Table 3.2.3-1
MCPR OPERATING LIMITS

WASHINGTON NUCLEAR - UNIT 2

Amendment No.62

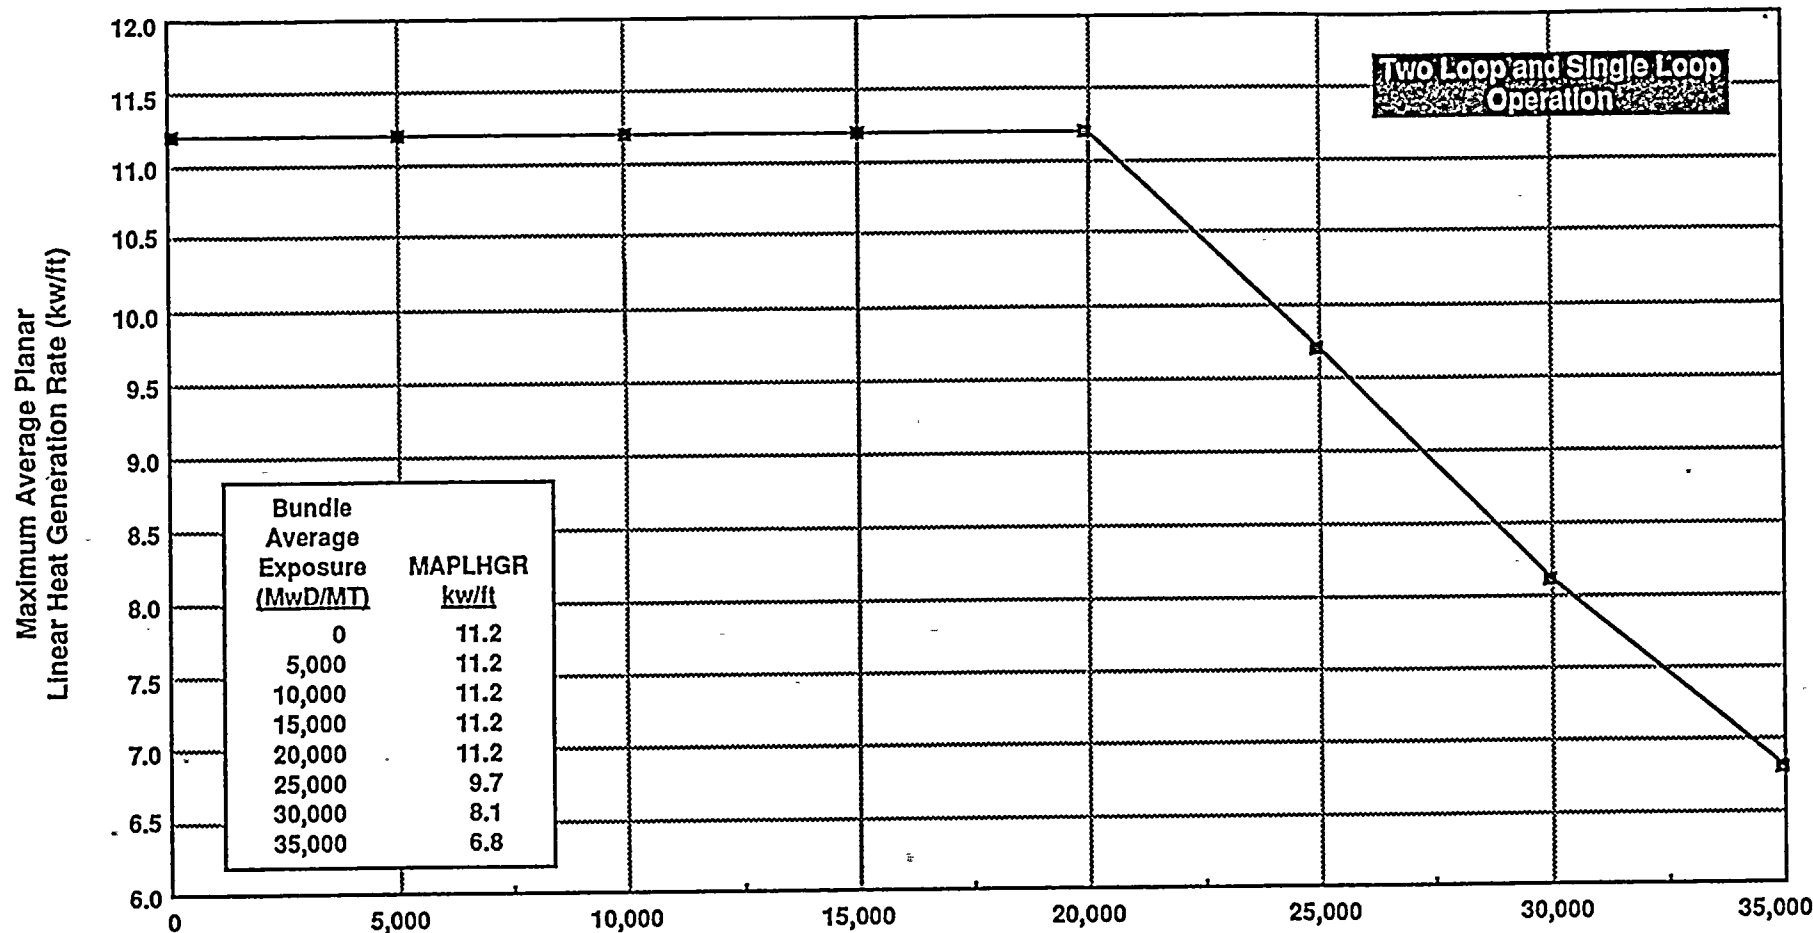
THIS CHANGE

*** FOR FFTR RATED CONDITIONS BEYOND ALL RODS OUT POINT, ADD 0.02 TO THE MCPR FOR BOTH GE AND ANF FUEL
Slowest measured average control rod insertion times to specified notches for all operable control rods for each group of 4 control rods arranged in a two-by-two array (seconds)

THIS CHANGE
